LAUREATE PARK PHASE 6

Owner James L. Zboril Lake Nona Land Co., LLC Applicant Heather Isaacs Lake Nona Land Co., LLC Project Planner Colandra Jones, AICP	Property Location: The subject property is located north of Tavistock Lakes Boulevard, west of Narcoossee Road, and south of Central Florida Greenway (SR 417). (±128.5 acres, District 1). Applicant's Request: Specific Parcel Master Plan (SPMP) approval for the Laureate Park Phase 6 residential development. The project is comprised of 886 residential units with 12 different lot types, including 747 detached single family units and 139 townhome units. The applicant is also proposing to have 151 units of the larger lot types to be gated. In addition to the residential uses, the project also contains areas of open space and a bicycle/trail network.	Staff's Recommendation: Approval of the request, subject to the conditions in this report.
Updated: March 23, 2015

DEVELOPMENT PLAN

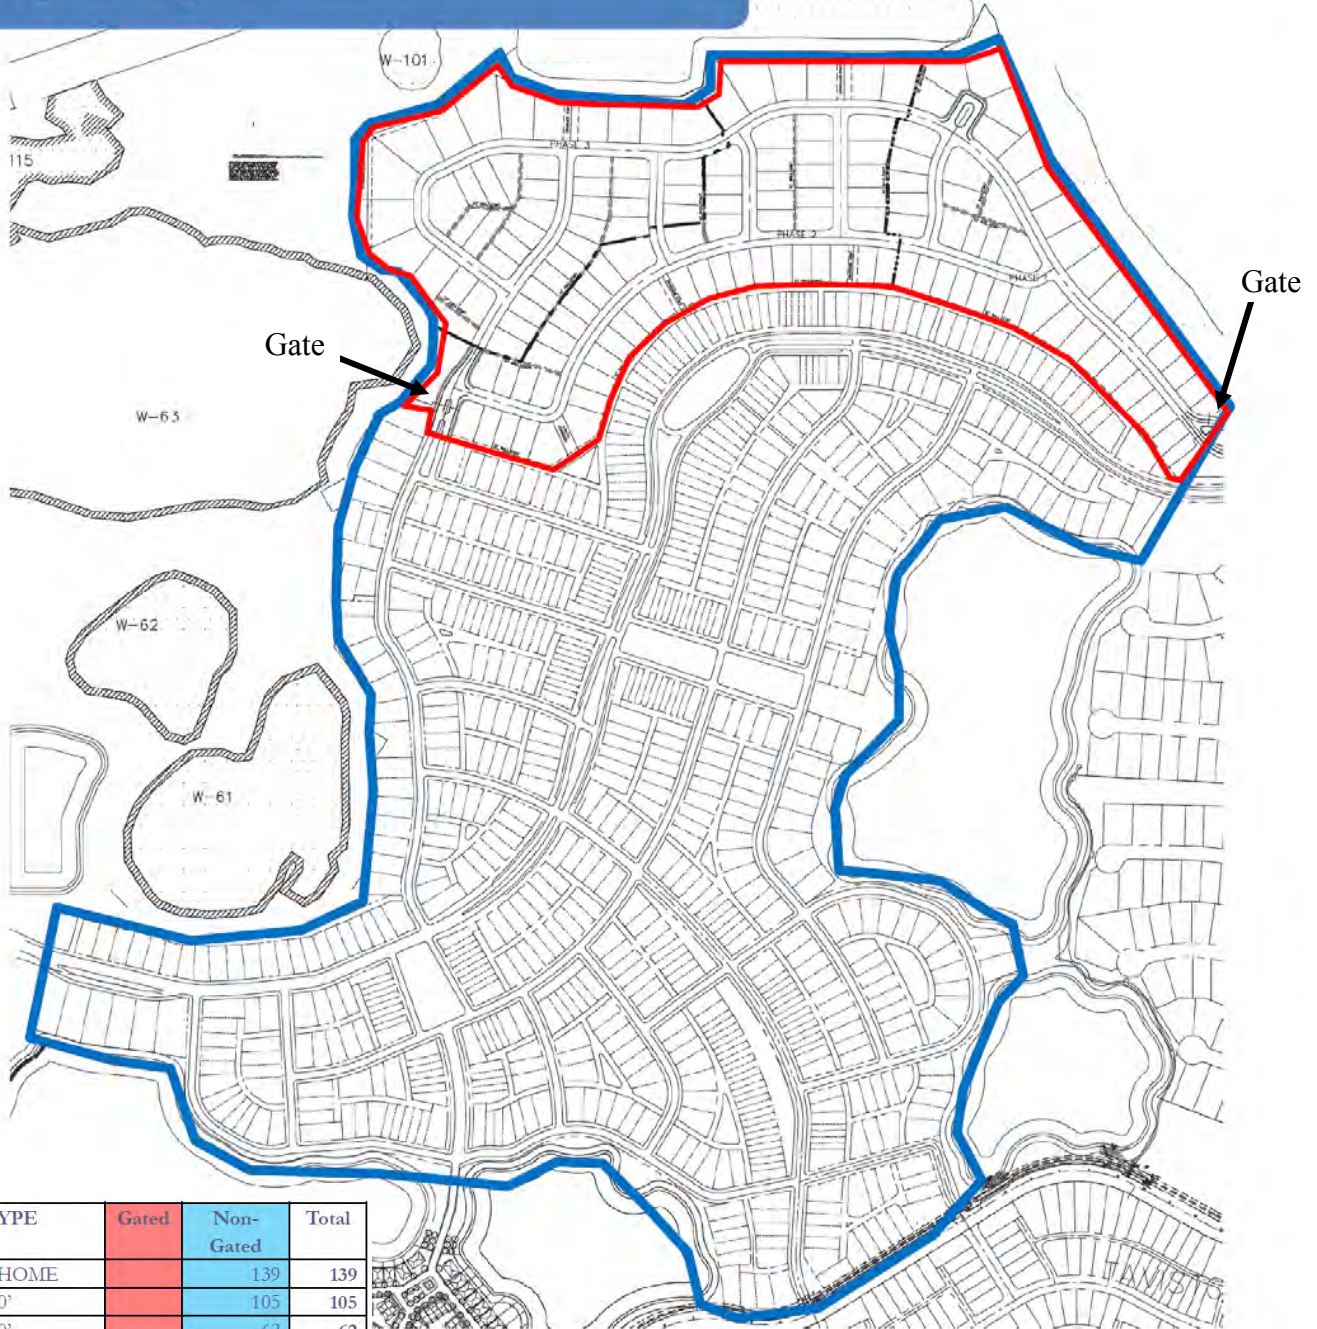
- If the lots south of Wetland #61 is rear loaded, add alley to the roadway map. This can be address at the Preliminary Plat stage.
- Show alley cross section for lot numbers 79, 80, 81, 251, 252, 253, 254, 255, 256, 382, 383, 384. This can be address at the Preliminary Plat stage.
- During the Preliminary Plat review, the City's Solid Waste Division and Fire Department shall review the alley conditions throughout the development to determine if a solid waste truck and/or fire truck can maneuver within the alleys.

TYPE "A" PARKWAY - WITH MEDIAN
100' - MIN ROW

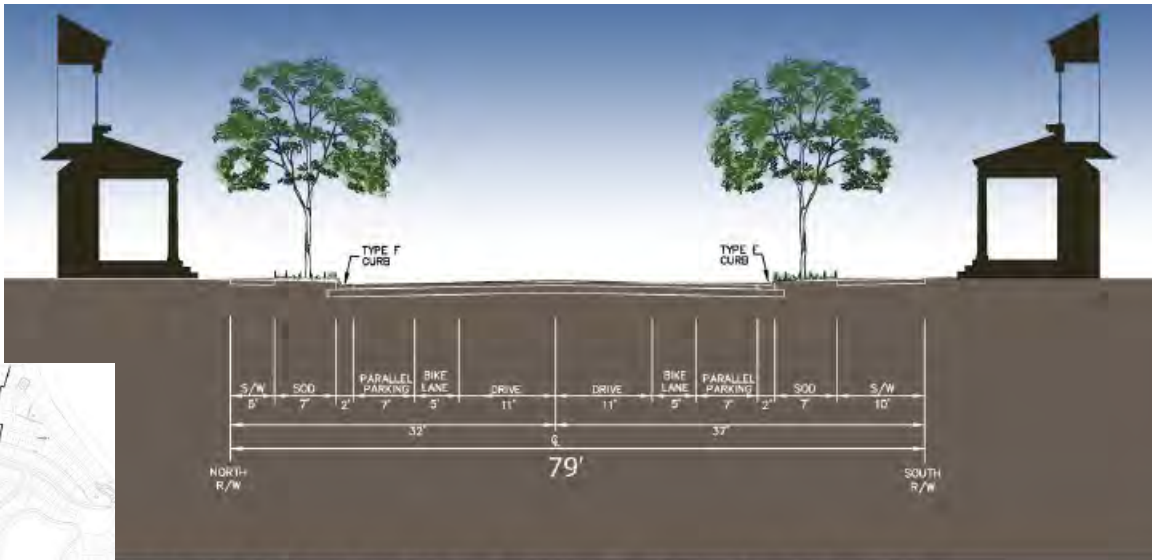
1. Section Type A:
 - Any median curb shall be either FDOT Type A or Type E. Flush curb shall not be used outside of the alleyways.
 - The 10' sidewalk shall be called out as a trail or multi-use path.

11. The median opening shown where Section 6 intersection Section A across from the Section B pair shall be removed due to the close intersection spacing.

TYPE "5" MODIFIED SECTION WITH TRAIL /PARKING
69' ROW

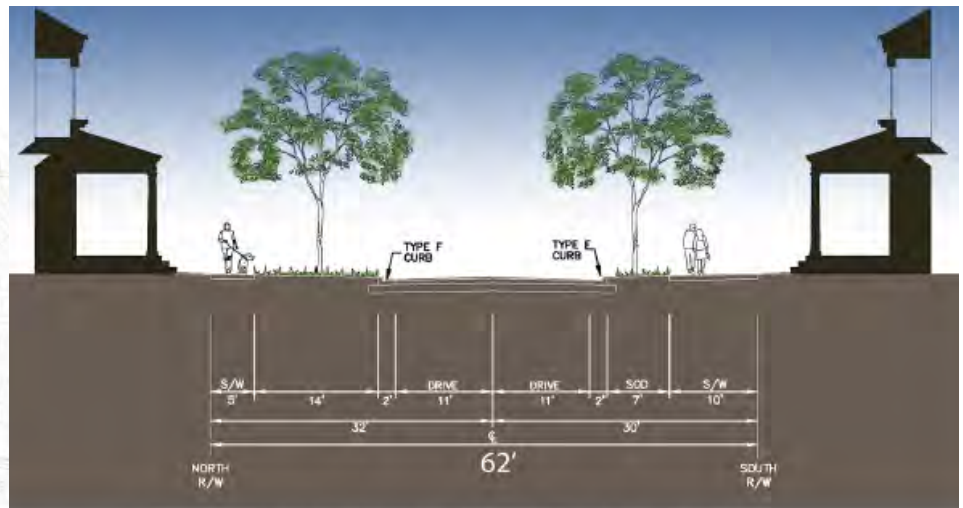
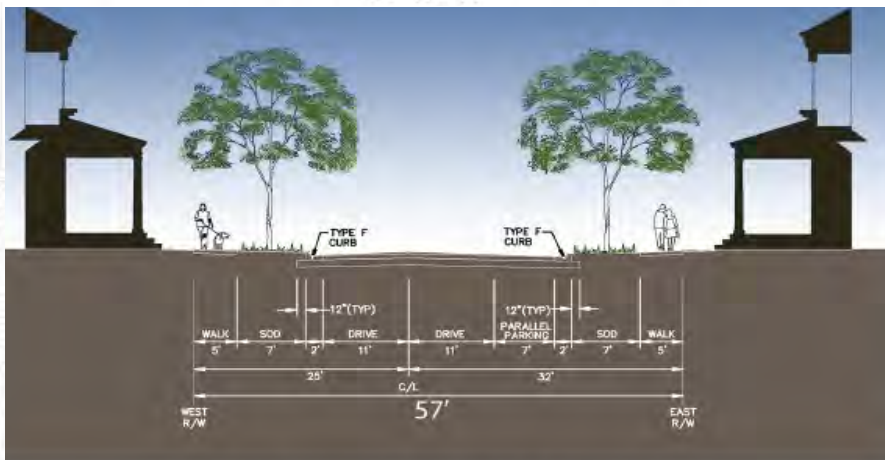
2. Section Type 5 w/Trail and w/o Trail:
 - Both of these sections shall include a 5' wide bike lane in each direction since they tie into Section Type A and are part of the main east-west roadway.

TYPE "B" PARKWAY ONE WAY
48,5' ROW

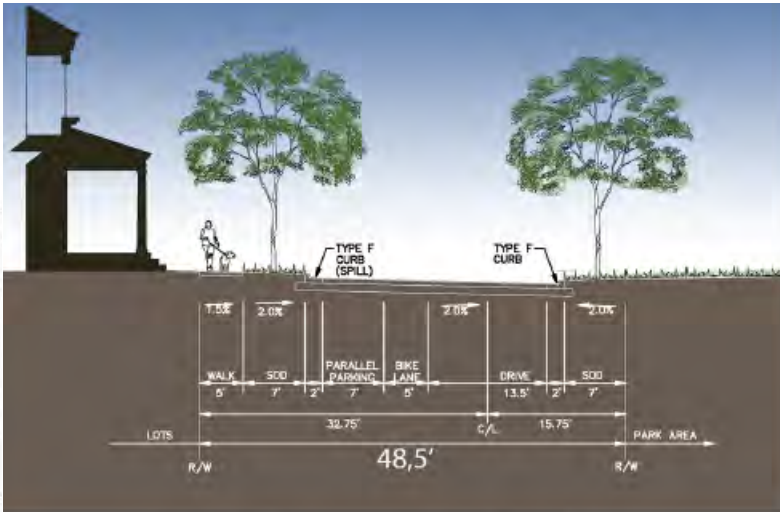
3. Section Type B:
 - The curb along the park shall be FDOT Type F. Flush curbs shall not be used outside of the alleyways.
 - A 5' sidewalk shall be provided on the park side of the road if a continuous sidewalk through the park is not constructed.

TYPE "8" REAR LANE / ALLEY
26' ROW

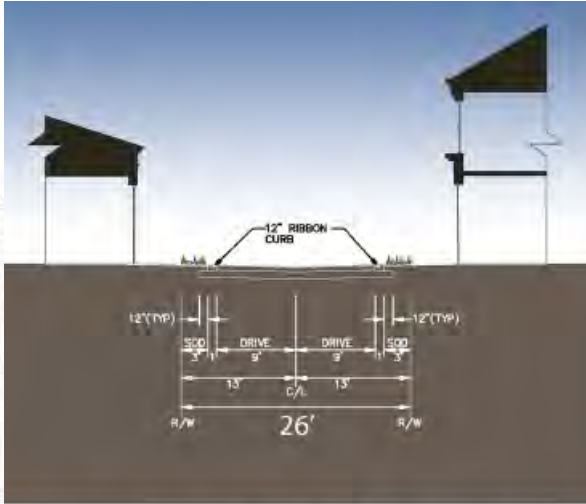
- The 4 short alleys serving the 11 lots facing onto the mews leading to the lakes on the east and west sides of the project shall be shown as Type 8 - 26' alleys.
- The divided Type 6 roadway leading to the west gated entrance to Phase 6 shall be modified to provide safer, direct access to the driveways of the 3 lots on the west side of the roadway OR a plan shall be provide to illustrate how the driveways for these lots will be configured.
